DS-K1T344 Series MinMoe Terminal
Release Notes (2025-07-30)

Device Model: DS-K1T344MX-E1, DS-K1T344MBWX-E1, DS-K1T344MBWX-QRE1, DS-K1T344MBFWX-E1 DS-K1T344MFX-E1 DS-K1T344EX-E1 DS-K1T344EBWX-E1 DS-K1T344EBWX-QRE1 DS-K1T344EBFWX-E1 **Naming Rule:** M for M1 card, E for EM card -E1 for POE, B for Bluetooth F for Fingerprint, W for Wi-Fi -QR for QR code reader	Firmware Version	ACS_344_F2pro_EN_STD_V4.47.0_build250722 ACS_344_F2pro_EN_NEU_V4.47.0_build250722
	Software	**HikCentral Access Control:** https://www.hikvision.com/en/support/download/software/hikcentral-access-control-v2-3-1/ **Please add device to HCP/HC AC with port 80, and port 8000 will not work**

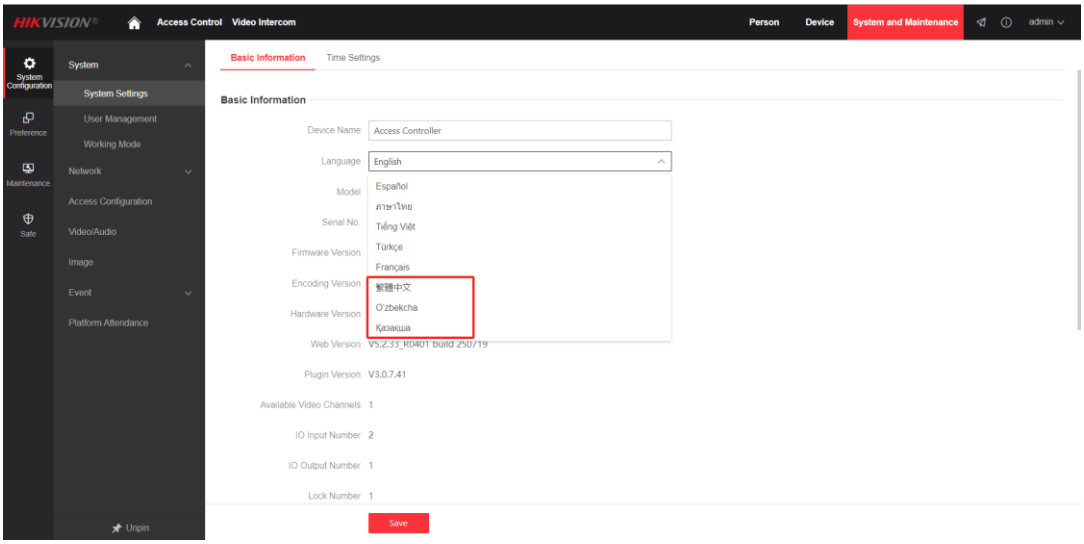
28. After door is opened, the status of door lock keeps the same to that of door contact

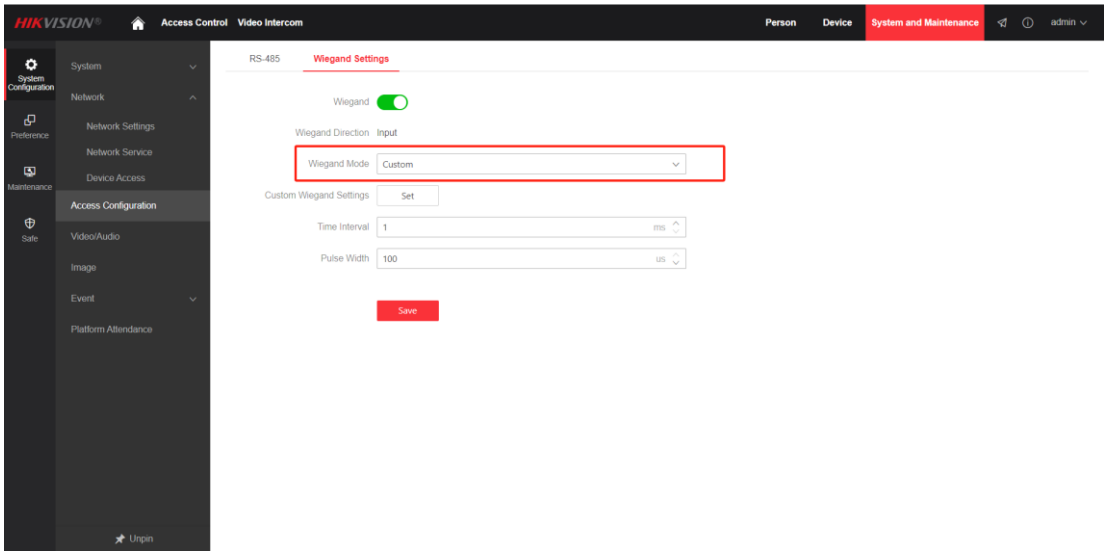
29. Support Traditional Chinese, Kazakh, and Uzbek

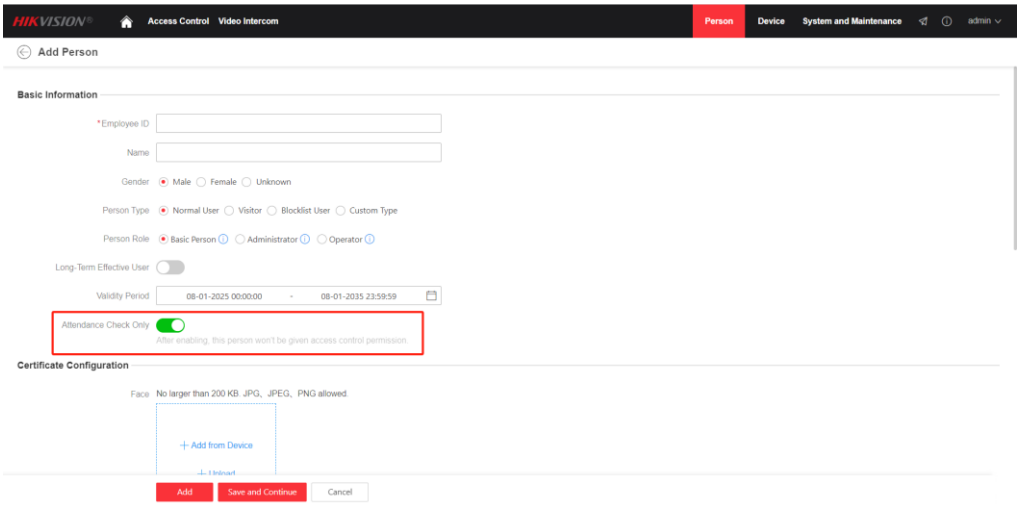
30. Support custom Wiegand

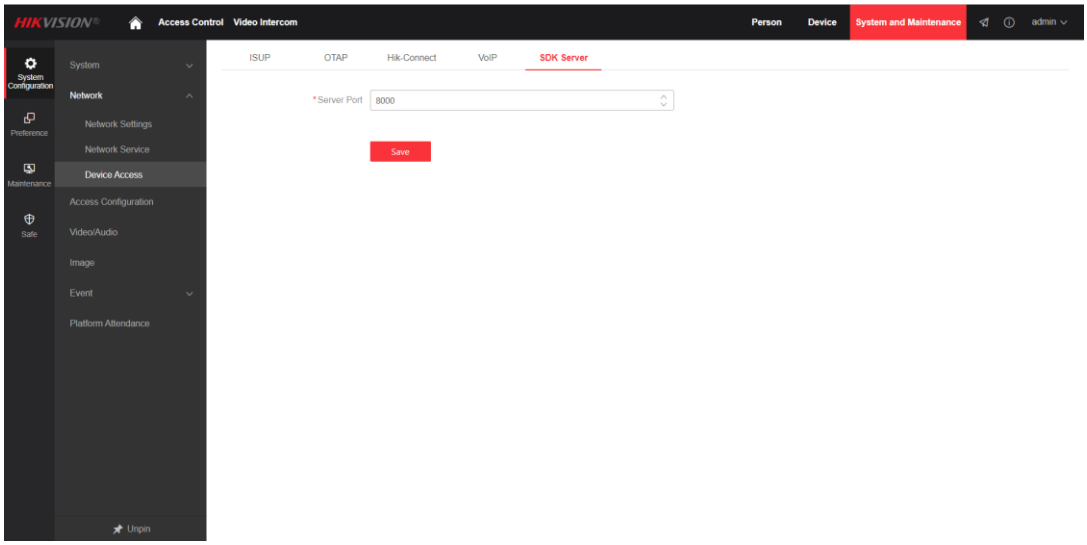
32. Support the same authentication when integration across devices

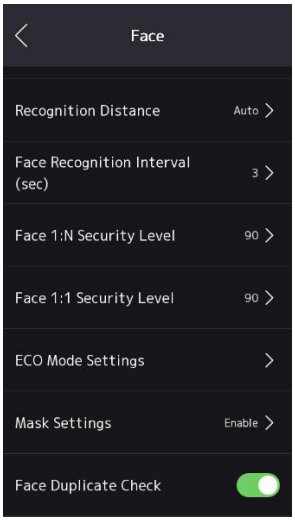
33. Support SDK 8000 port to work together with video intercom devices

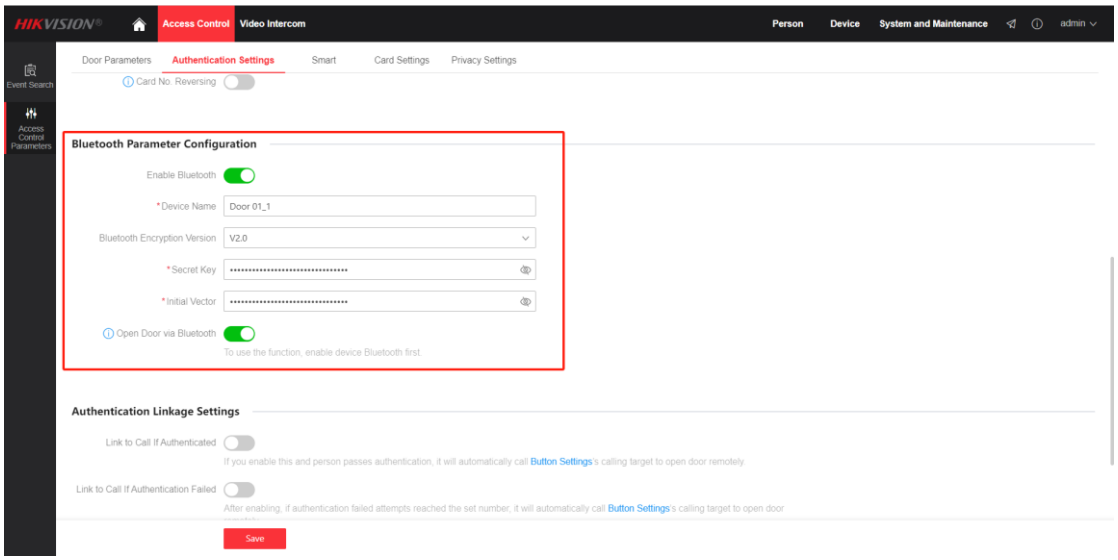
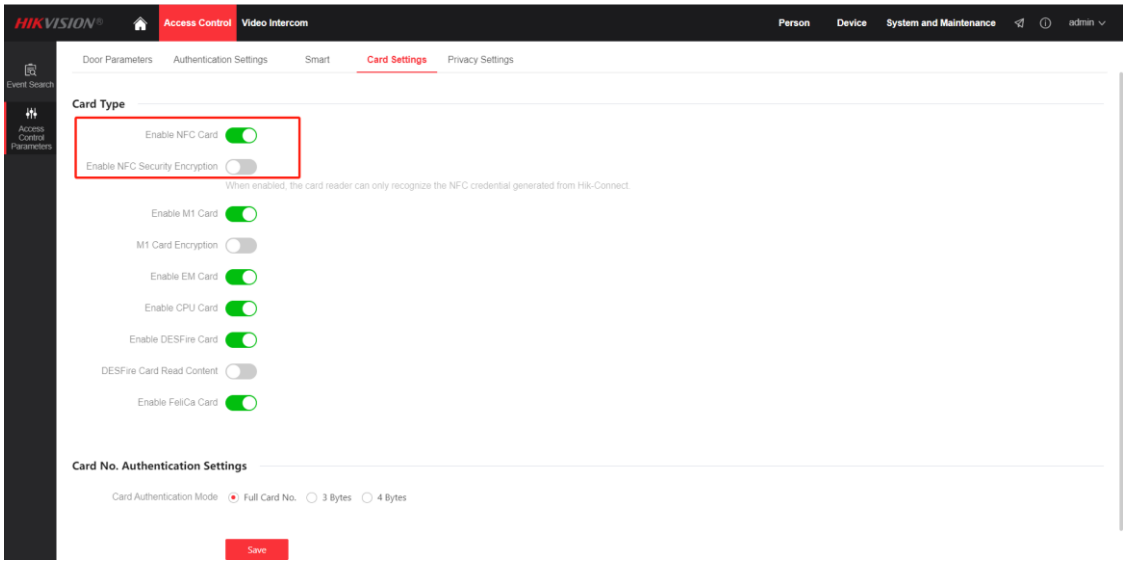
34. Support duplicated face picture check

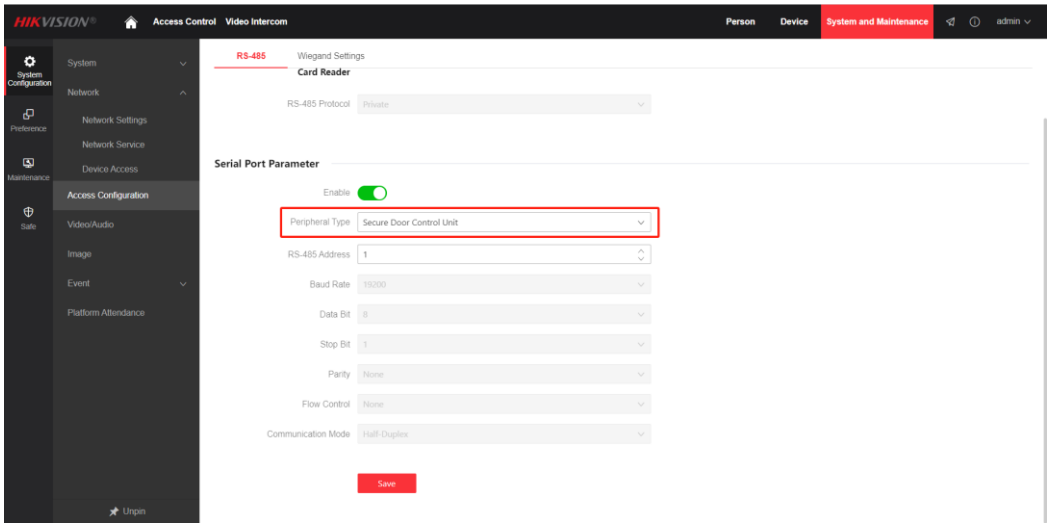
36. Support network diagnosis

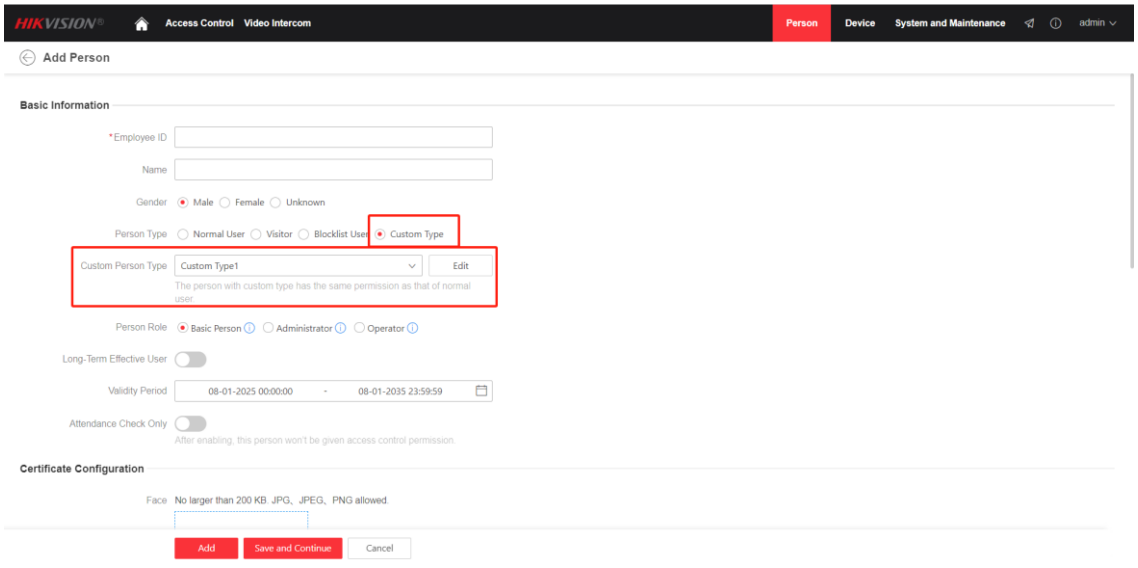
37. Support secure module encrypt and binding

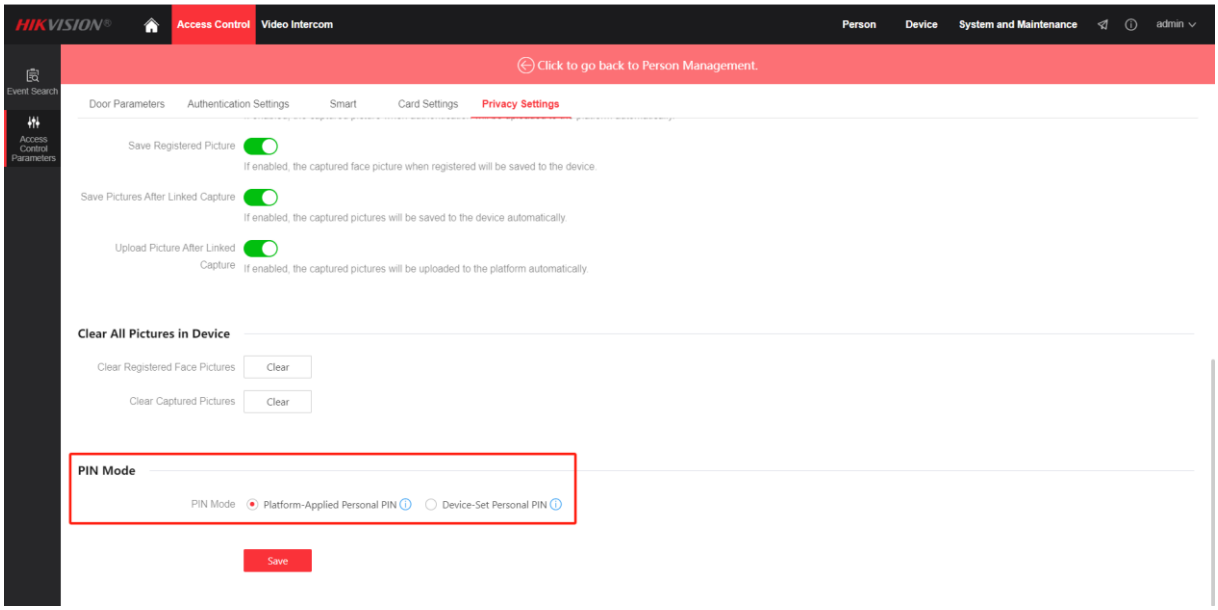
38. Support self-define person type, and the permissions are the same to normal person

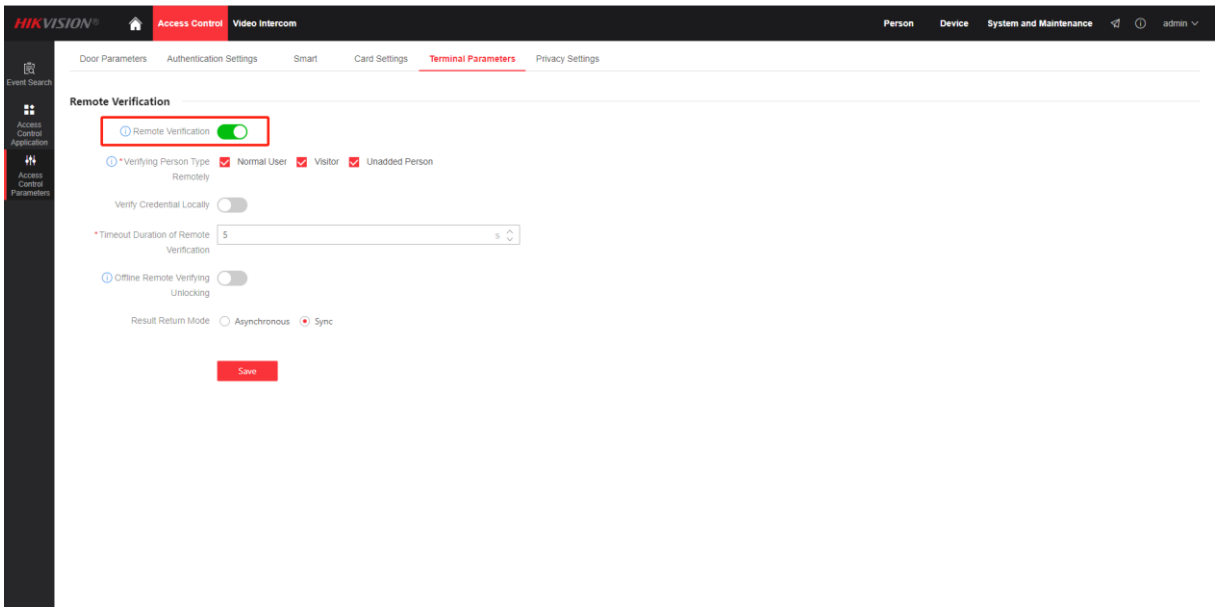
39. Support on-device PIN

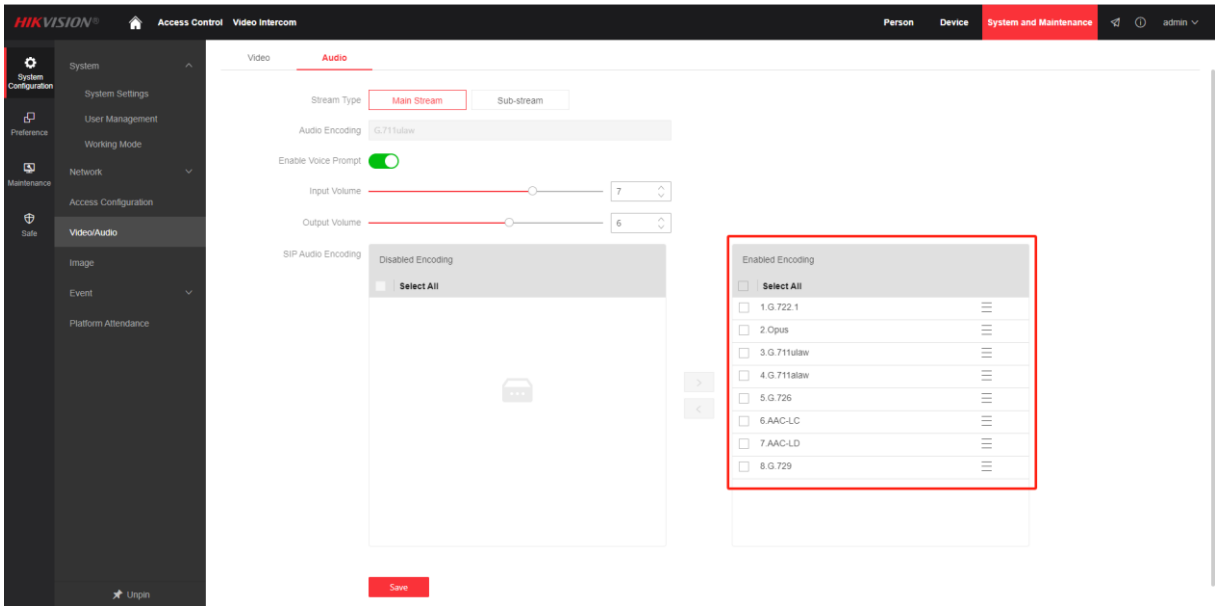
1. Support ONVIF protocol (only support login, register and get the video stream, not support video intercom)
2. Support remote authentication and group remote authentication
   a) After the remote authentication finish, the screen will display the result;
   b) Support configuration for remote authentication personnel scope, including ordinary personnel, visitors, and unregistered personnel
   c) Support display remote authentication timeout prompt
   d) Support to configure whether door will open after remote authentication timeout

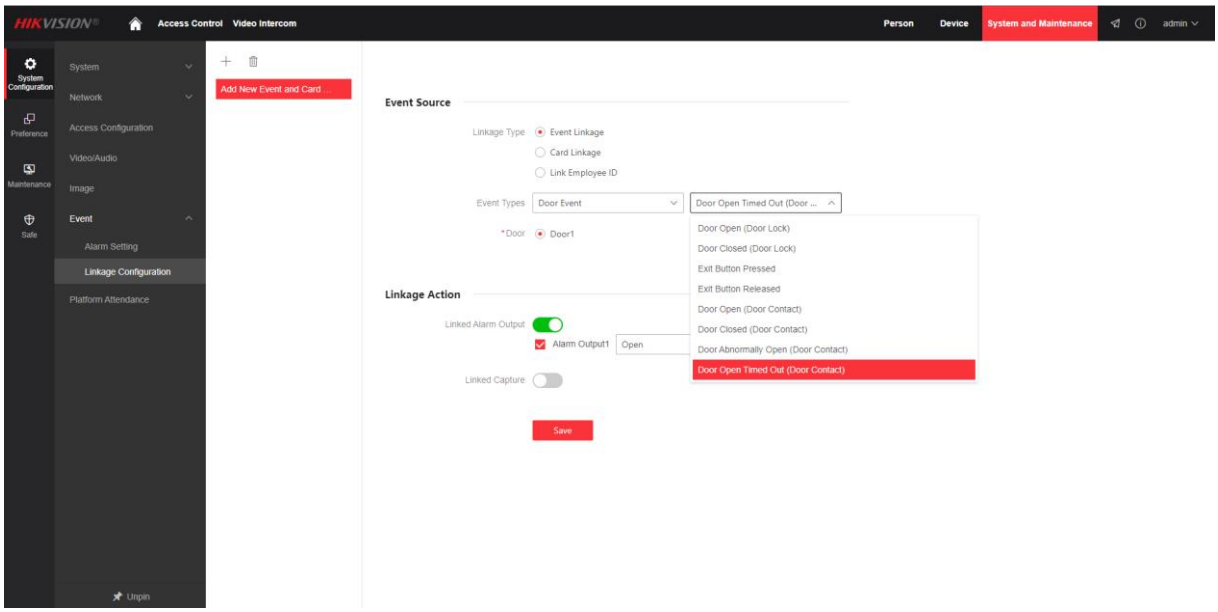
3. Compatible with 3rd party software which support SNMP protocol (such as MibBrowser Free Tool) to get the device online status. SNMP function is configurable in **system settings—basic settings—SNMP configure**, administrators can enable/disable SNMP, set the community name (similar to password for authentication), NMS server IP (Trap Host IP) and port.
4. Support more audio format: G722, G726, G729, AAC_LC, AAC_LD, OPUS

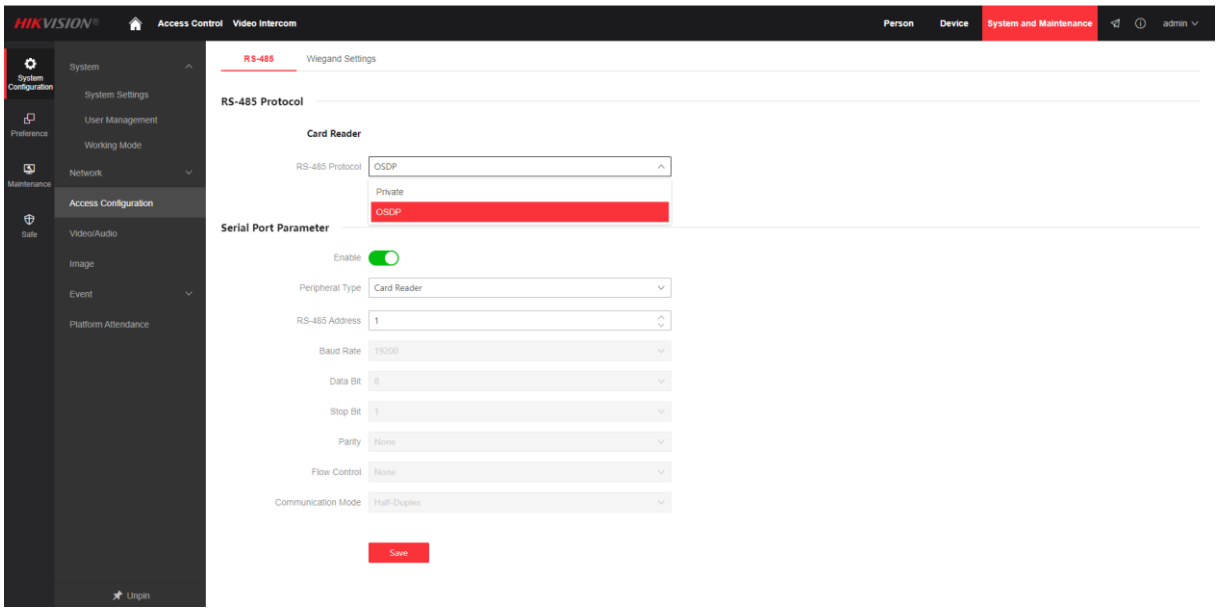
5. Support door open timeout alarm and prompt, self-define prompt and audio are supported.
   a) After enable this function, if door sensor is connected and open door timeout, the alarm will be triggered and users can see the prompt on the screen, K1T344 will play the alarm audio.
   b) The timeout duration range is 0-255s, by default it is 0s, meaning this function is disabled.

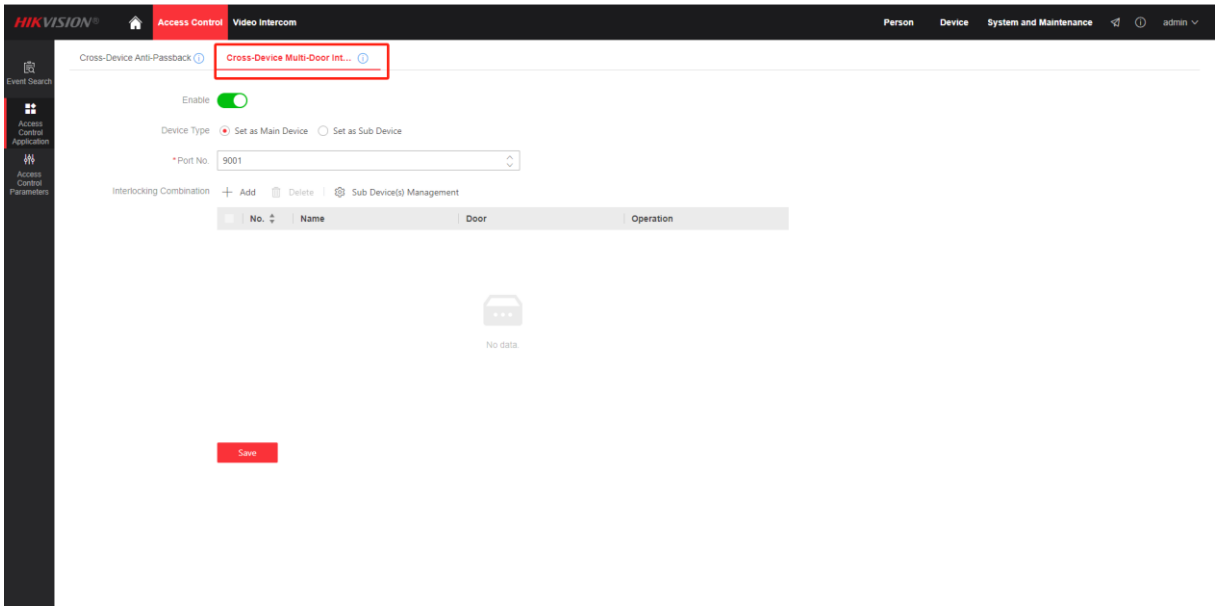
6. Support OSDP to integrate with 3rd party readers

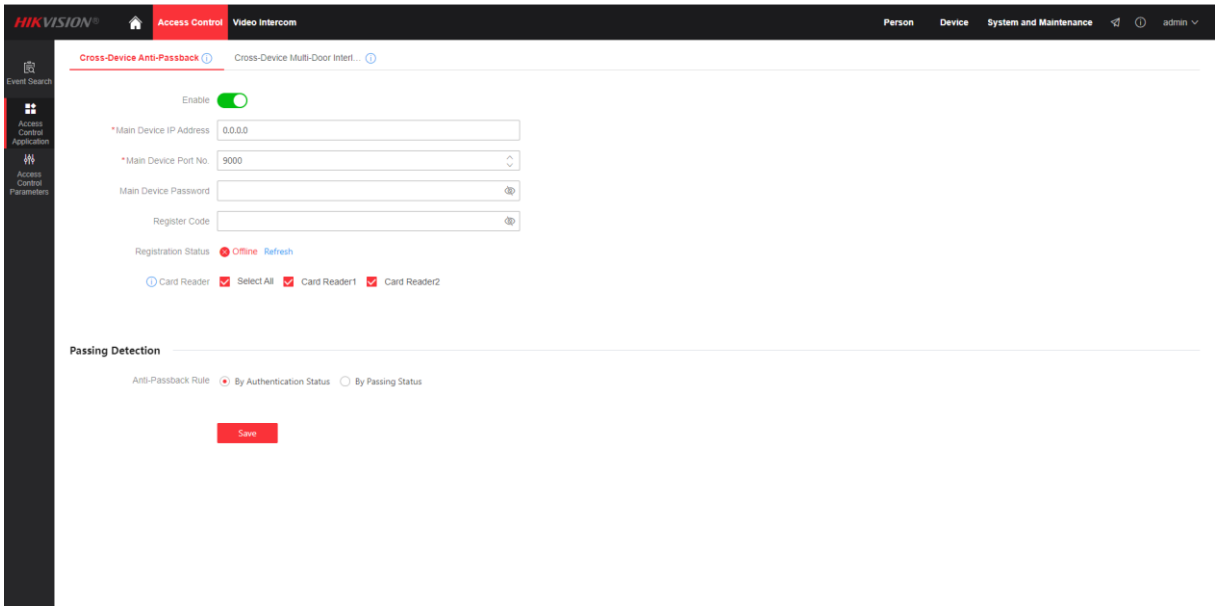
7. Support configure inter-lock among K1T344 in device web page
   a) Support to be both main device and sub device
   b) When K1T344 is the main device, support 15 sub devices; 16 inter-lock groups are configurable, and each group supports 2 doors
